Docket Item # 3 & 4
BAR CASE # 2015-0189 & 190

BAR Meeting
July 1, 2015

ISSUE: New Construction: Buildings 1 and 2

LOCATION: 2 Duke Street

BLDG 01 - ENLARGED EAST ELEVATION

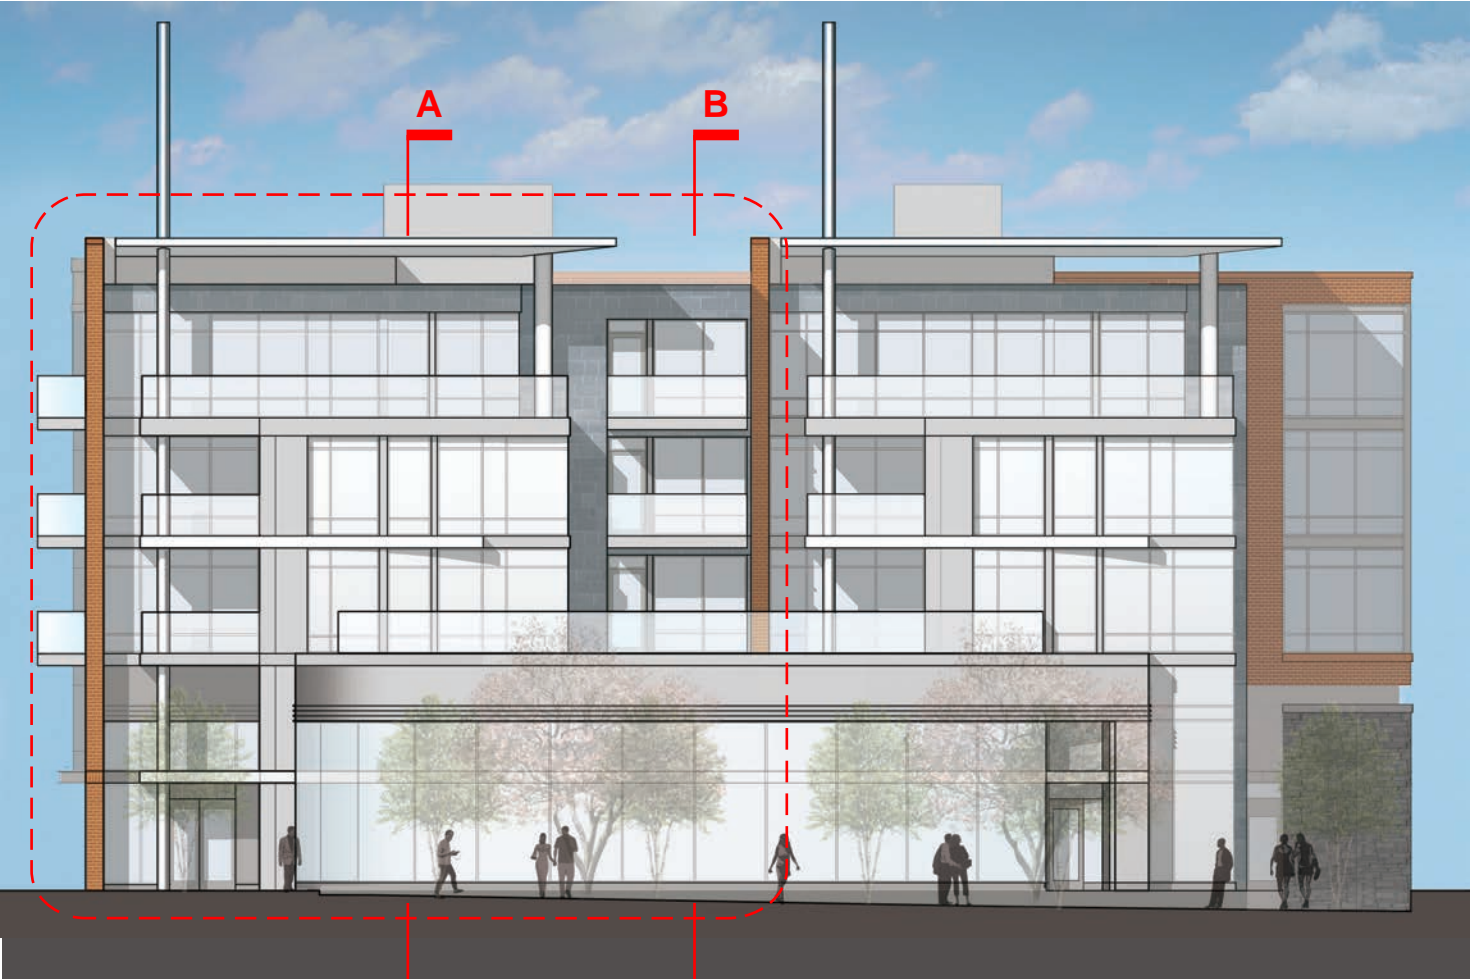
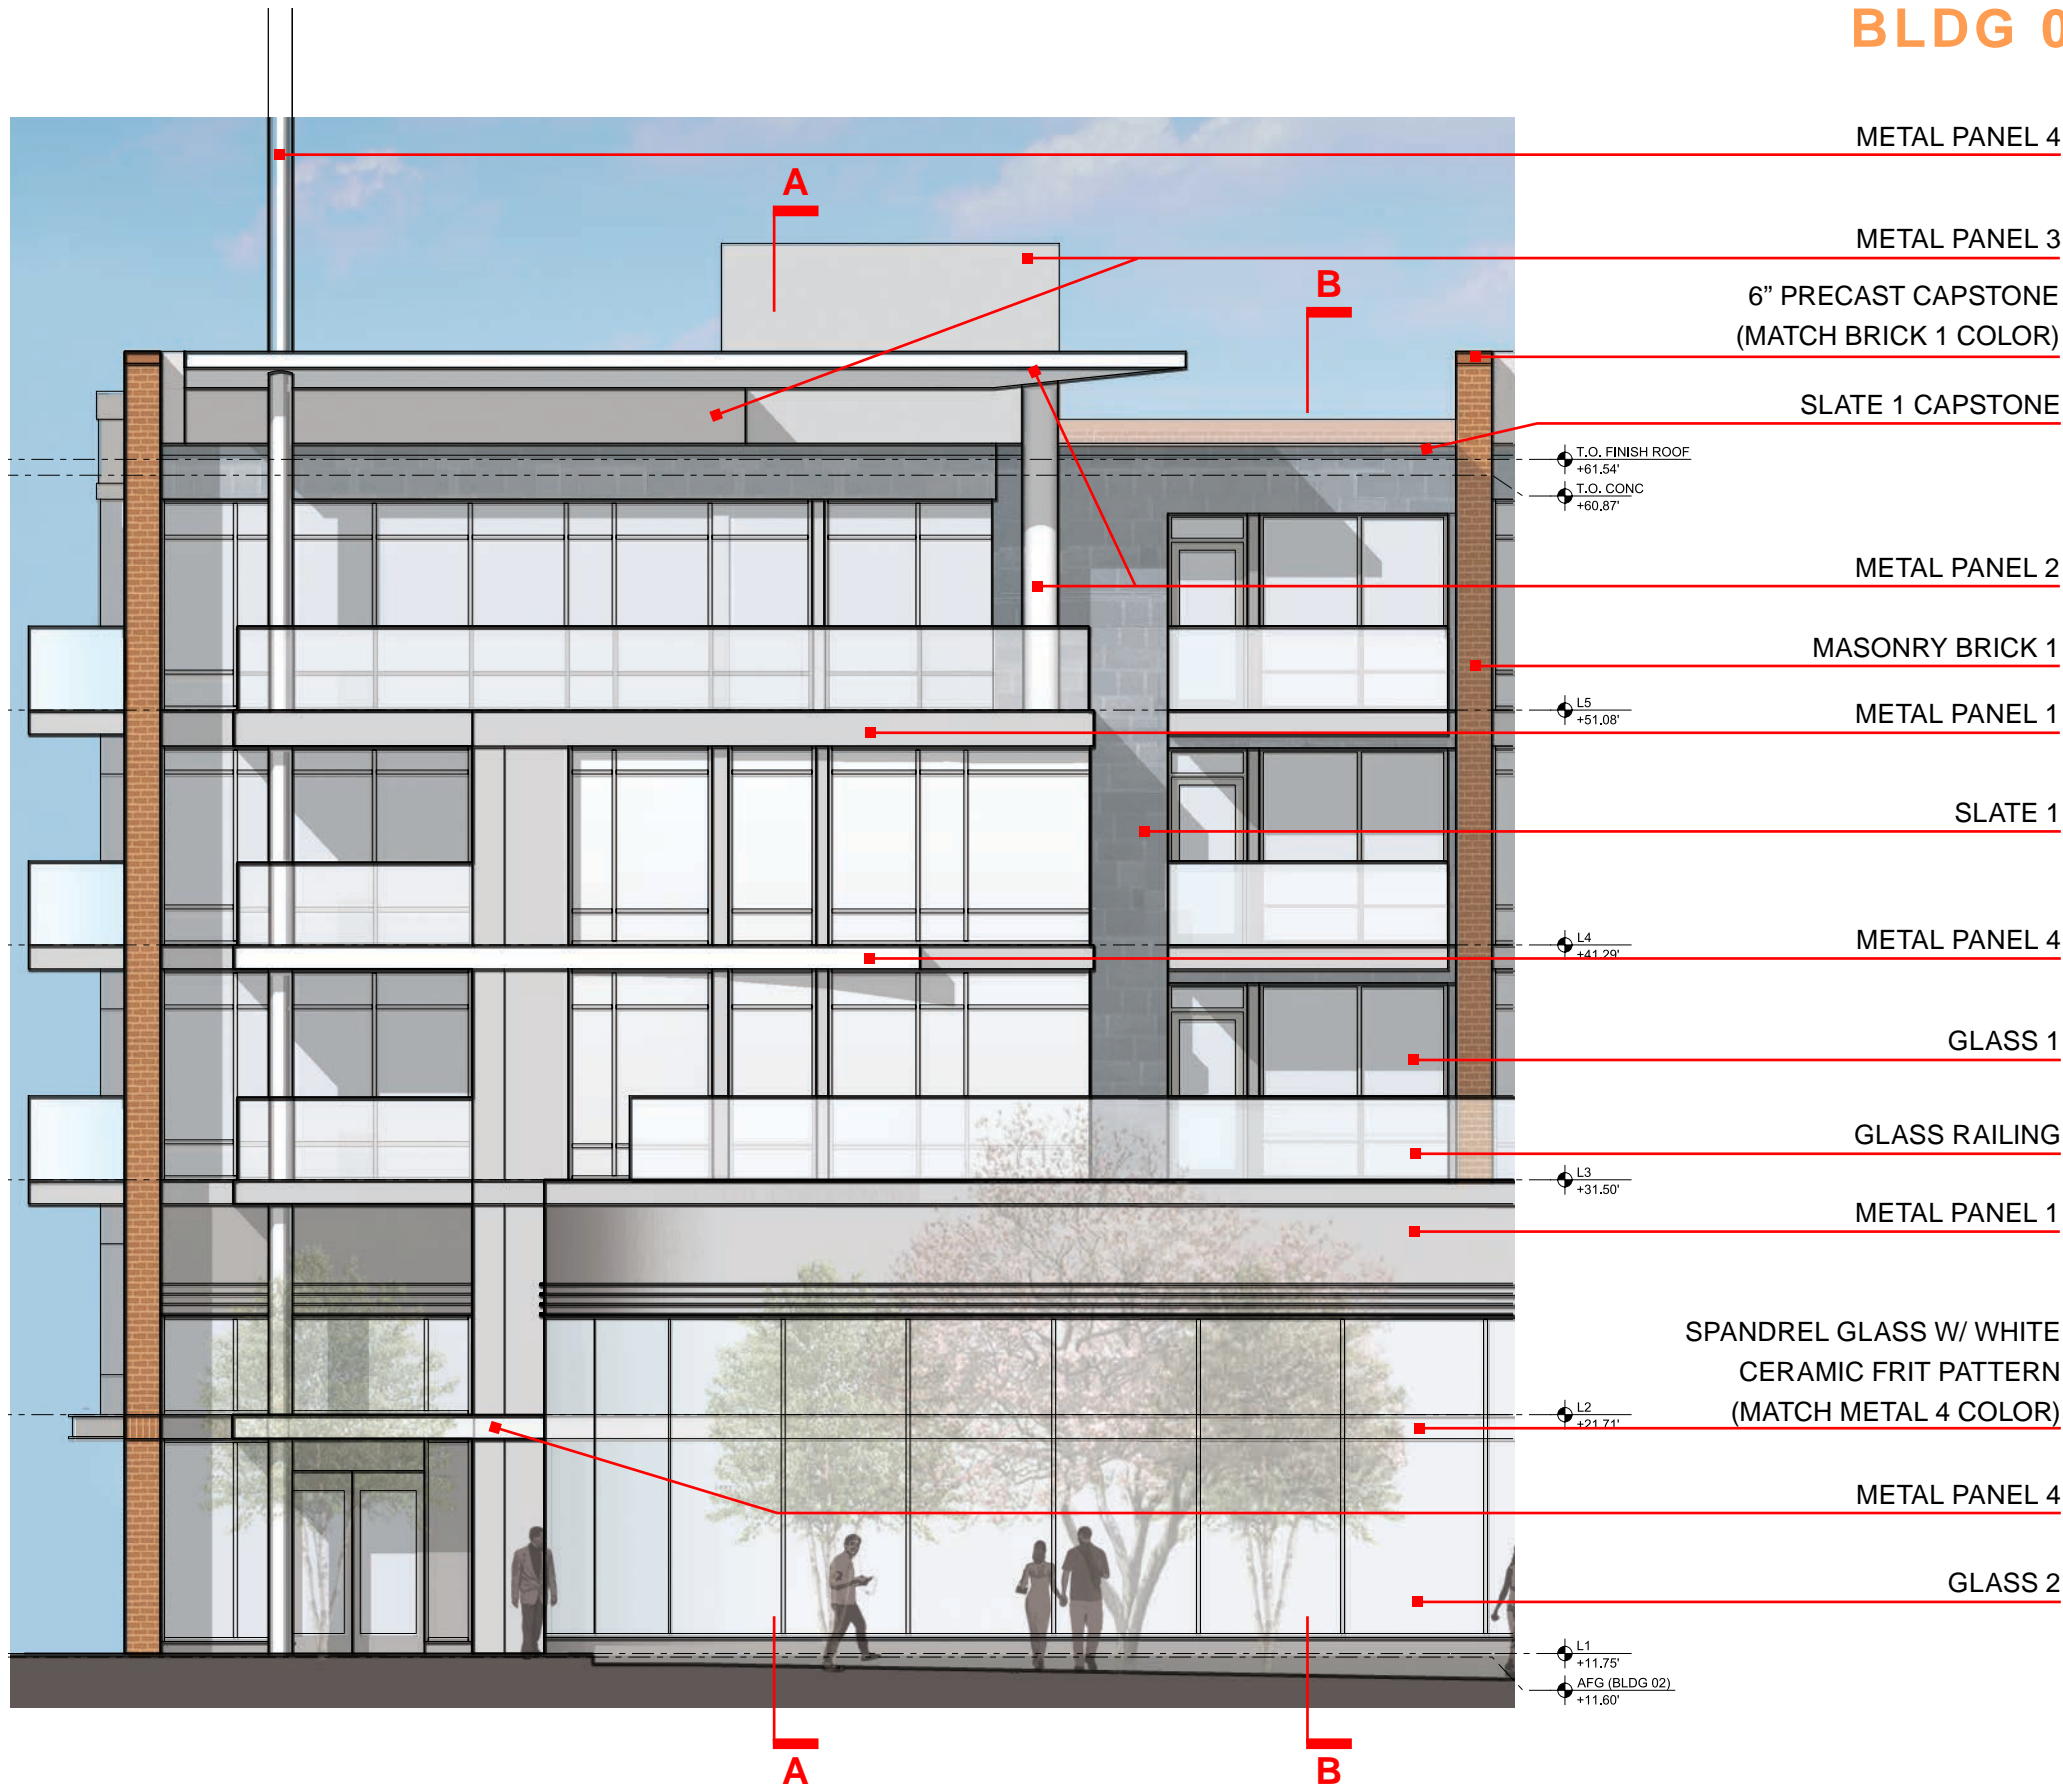
Ms. Kelley asked to see more context with the neighboring properties. She liked the design of the east elevations but agreed that the restaurant area needed additional work. She thought that a moderate amount of differentiation between buildings 1 & 2 could be good but should not be done in a way to lose the present rhythm of the east facade. She thought the entrances should be more grand, especially at the eateries and asked if it were possible to open up the kitchen area at the restaurant to make the north side of the building more welcoming from The Strand. She agreed with the staff comments for further study and deferral.

In addition, the BAR generally supported a curving glass form for the restaurant but wanted it to be more substantial, in order to be a signature feature and to read as a two-story space, reflective of the airy interior. The current design approach is capped by a heavy ribbed fascia band reminiscent of the Art Deco style that is somewhat foreign to the rectangular vocabulary of the rest of the building. Staff would prefer to see less of the ribbed metal banding and more glass, as the current proposal makes the restaurant's form seem like a disparate component that is not integrated with the overall design. Staff has no objection to the curved glass railing above the

fascia but finds that it will be better integrated if the area below has more glass and less metal panel. Such a change could also influence the east façade of the residential units above, further differentiating the waterfront elevations of Buildings 1 and 2.

BLDG 01 - ENLARGED NORTH ELEVATION

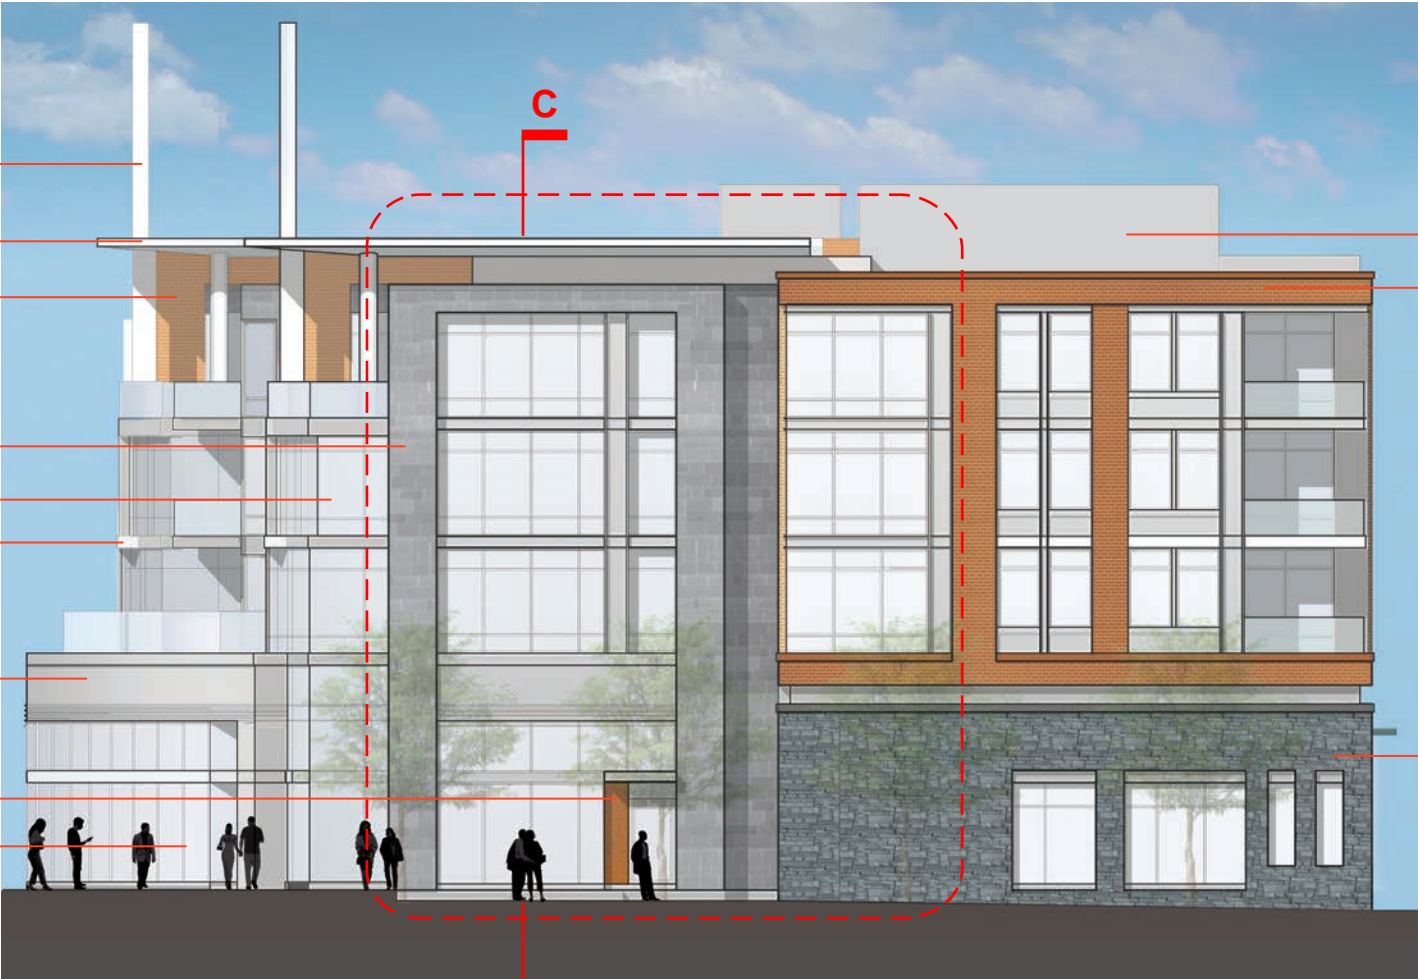
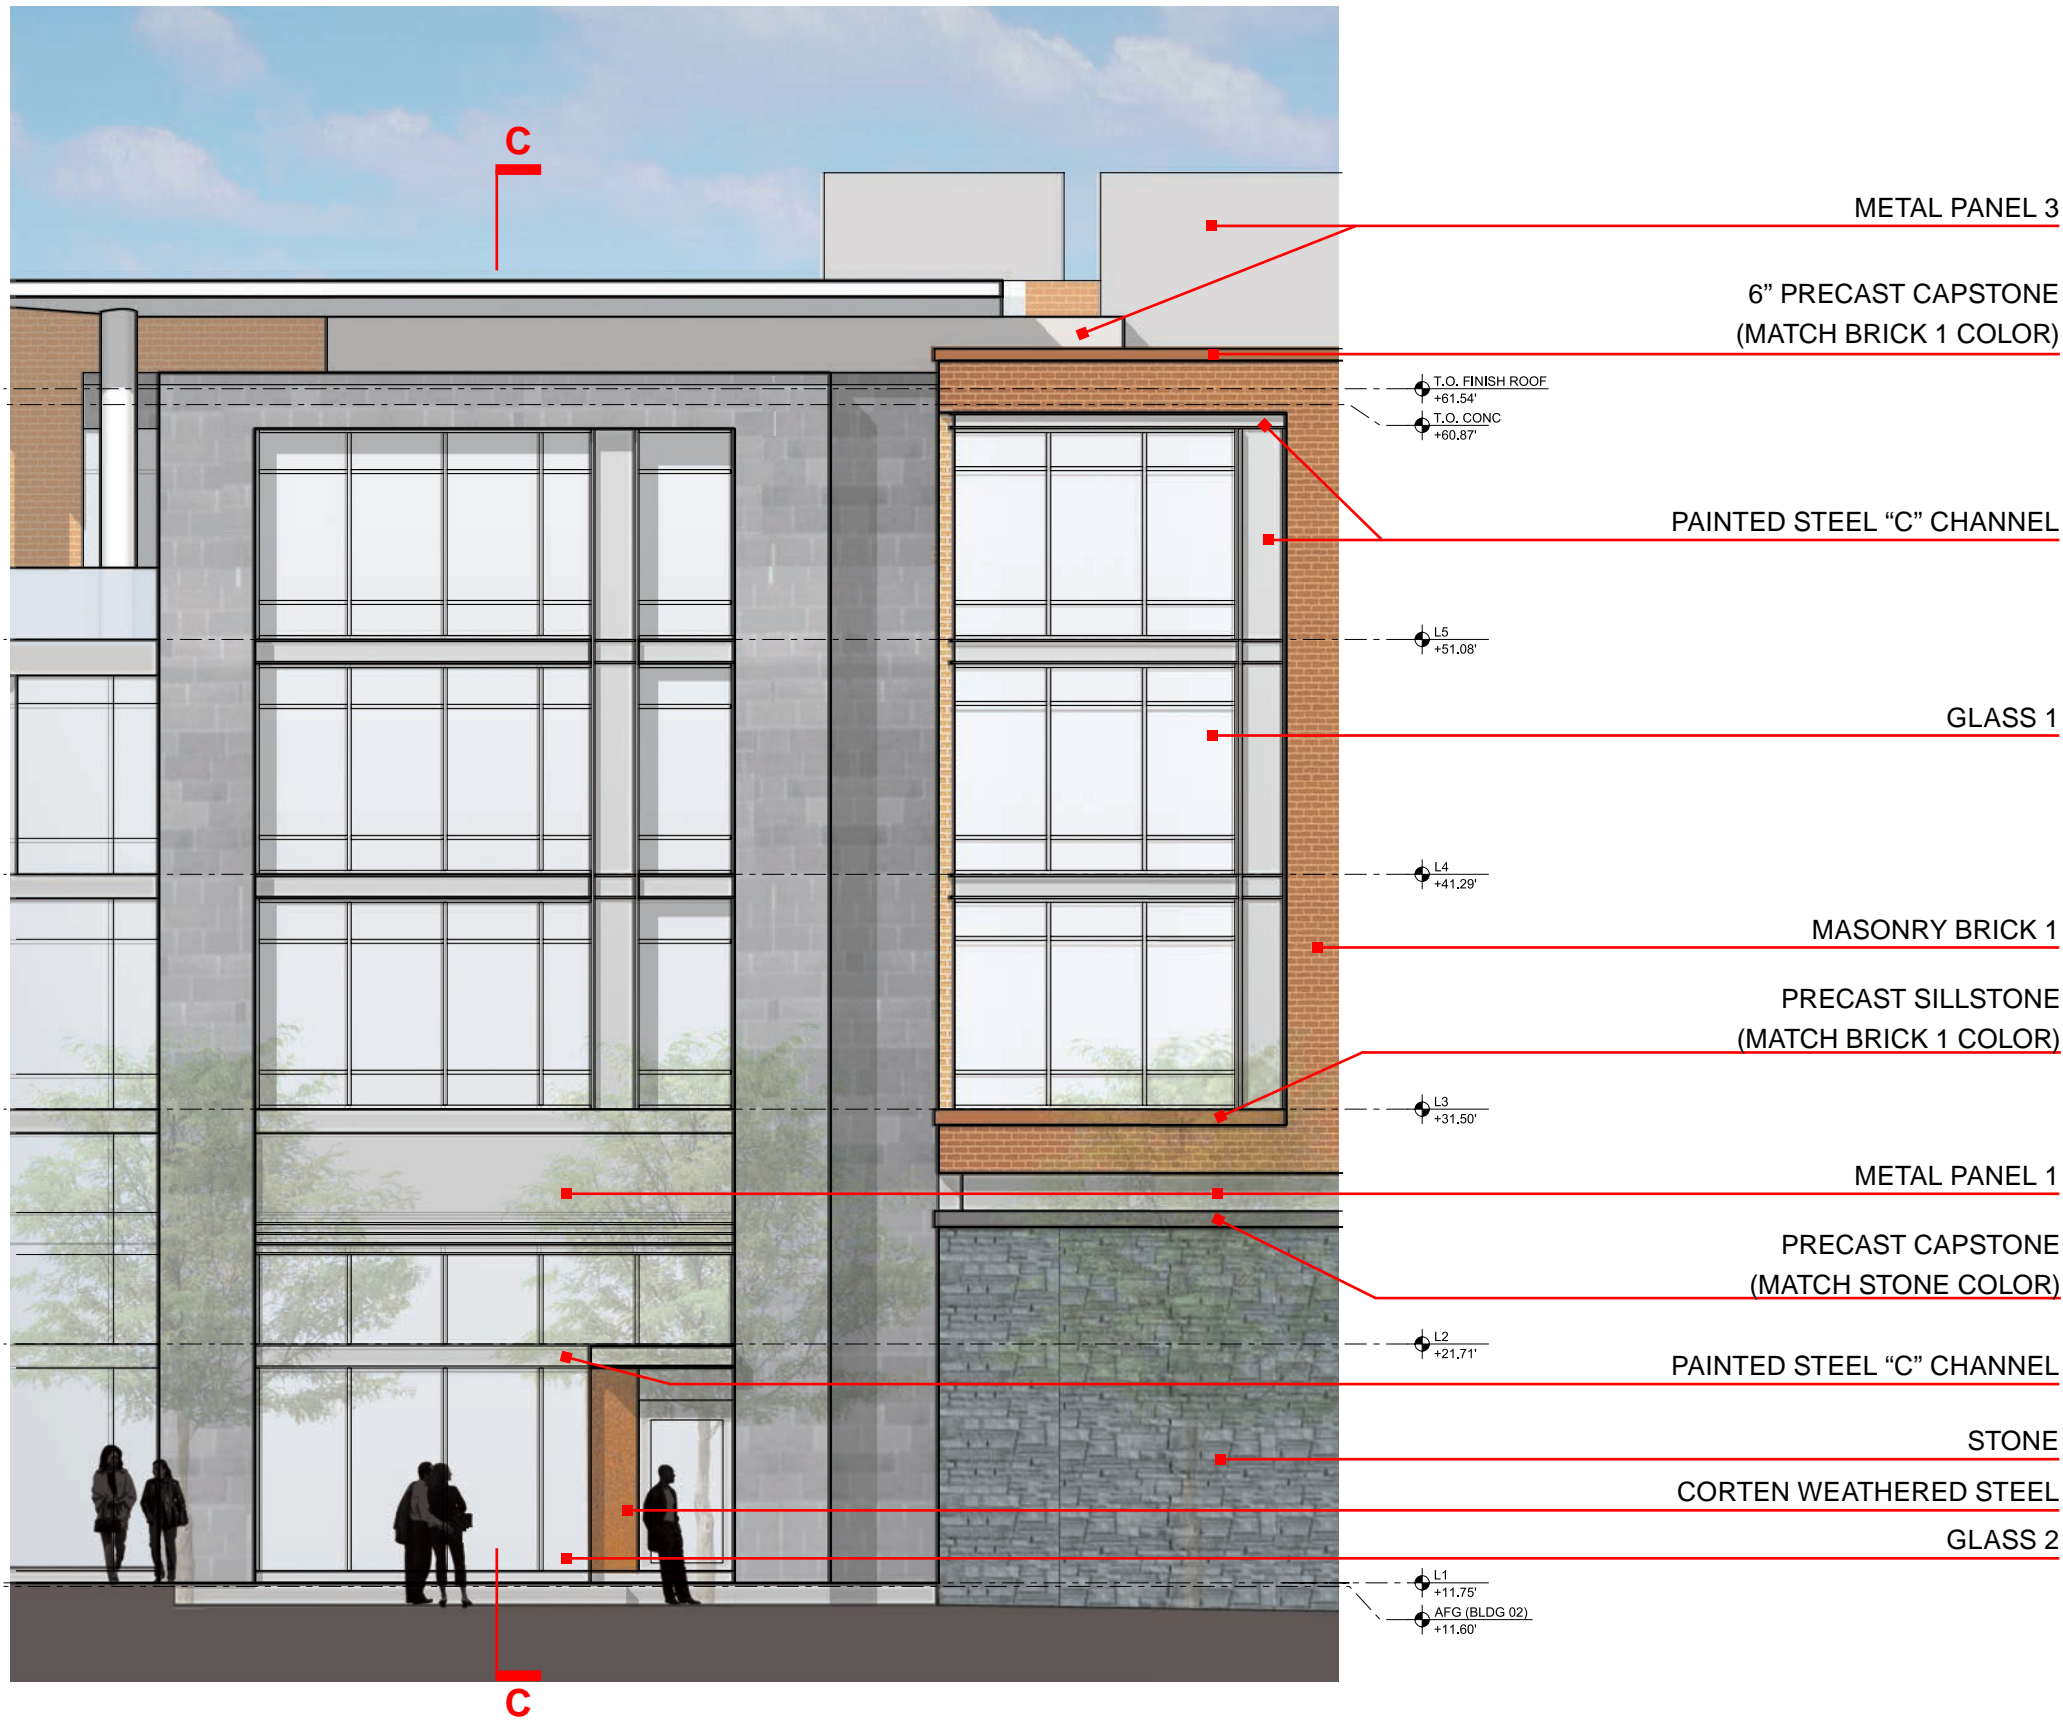
Ted Pulliam, 2506 Sanford Street, thought that the north elevation of Building 1 had an overly large stone wall that would not attract people from the park.

- b. Add more detailing and surface differentiation—such as banding applied with smooth cut stone—within the stone base to break up the solid two-story stone wall.

- c. Select a stone lighter in color and with a more random rustic rubble configuration, similar to that at Fitzgerald’s Warehouse.
 - d. Remove the awnings above the garage doors and recess the garage and loading doors.
